**FINAL**  
**Environmental Impact Report**  
**Oak Park Properties Specific Plan**  
**Pleasant Hill, California**

**State Clearinghouse Number: 2018112058**

Date: January 6, 2020

**Figure A-1**

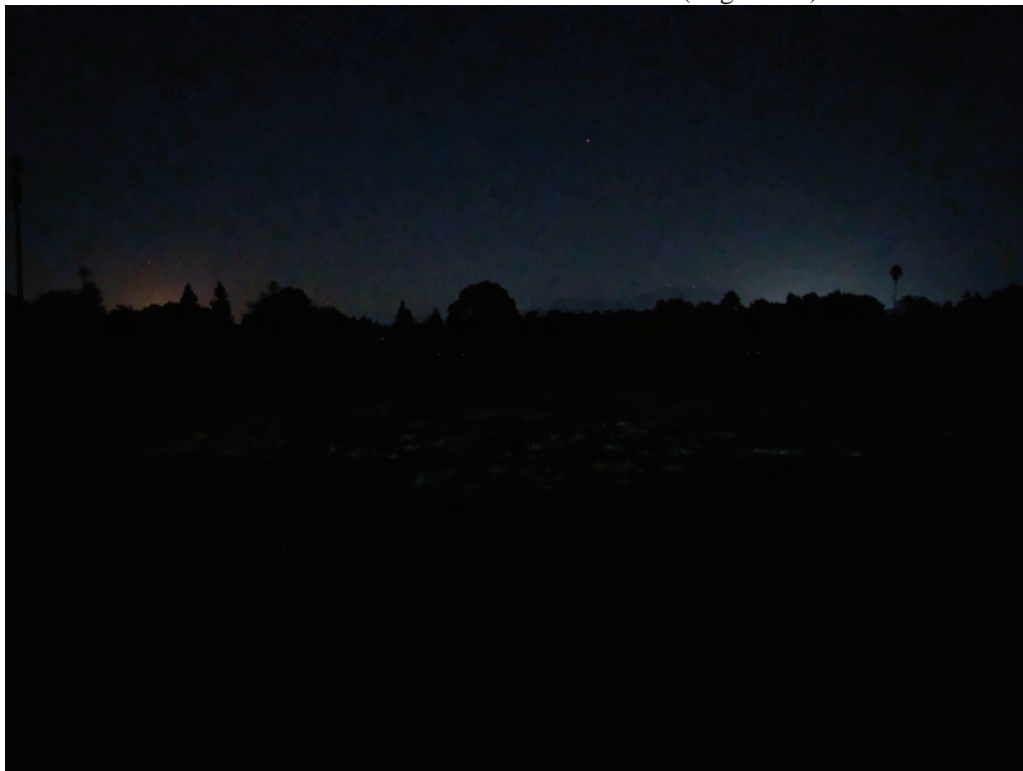
6. The DEIR does not provide illustrations showing daytime and nighttime views of the proposed new light poles from the following viewpoints: 17
    - From the west (current library/new residences) across the project site towards Grayson Creek and Mt. Diablo. (See Figure A-1)

25. Daytime and nighttime views of the existing site from Monticello Ave. are provided on Figure A-1. Installation of 70 foot light towers would be completely out of character with the site and would have an adverse impact on existing public views of the site, which currently consists of open space, the riparian corridor, and Mt. Diablo. They would also be out of character with the site as planned after development. As noted above, the tallest structure planned for the Civic Project site is the new library (30 feet tall). The proposed light poles for the new athletic fields would therefore be more than twice as tall as the library and also twice as tall as the new residences across Monticello Ave. The floodlights will tower above all the structures on the Project site as well as existing and new trees.

Please see Master Response 4—Lighting and Response to FPHC-35. As described in the Draft EIR there would be no significant impacts on the quality of public views of the site. As shown in Exhibit 3.1-2 through Exhibit 3.1-7, which include pictures of the proposed lighting poles, the existing daytime and nighttime views from the identified viewpoints are not substantially impacted by the proposed plan. The suggestion to limit the Civic Project component lights to the same height as the streetlights included in the new library building would not be feasible as it would not allow for sufficient lighting to safely illuminate the athletic fields.

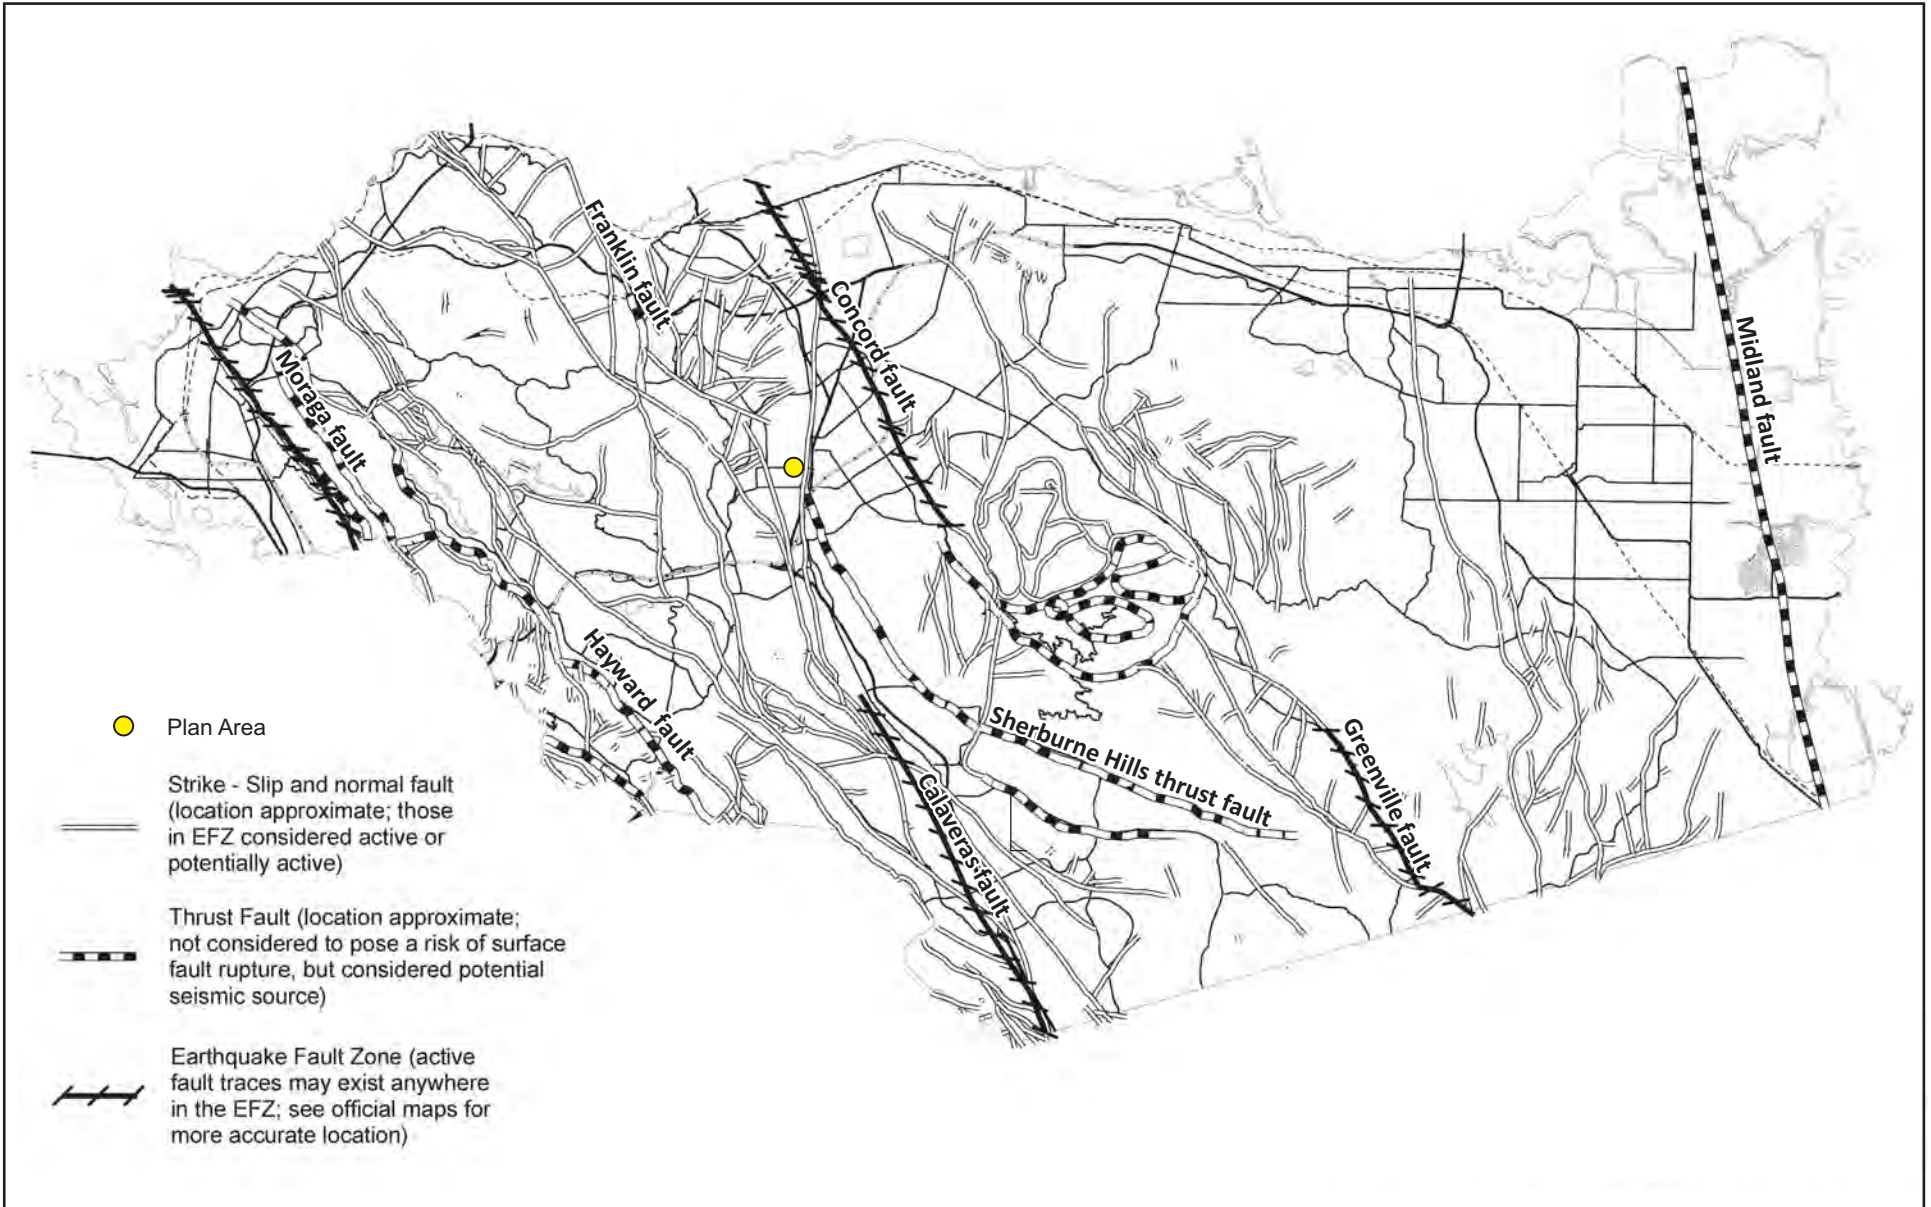
| 3- Please provide the Scale & a North Arrow on the Regional Fault Map in Exhibit 3.5-1 on page 3.5-5 of the Draft EIR Report. This comment is equally applicable to many of the maps included elsewhere in the Draft EIR. | 3 |

The commenter provides a comment about Exhibit 3.5-1 and asks that all exhibits include a scale and north arrow, where applicable.

To provide further clarity, the Earthquake Fault Zones (EFZ) are shown and named in Exhibit 3.5-1.
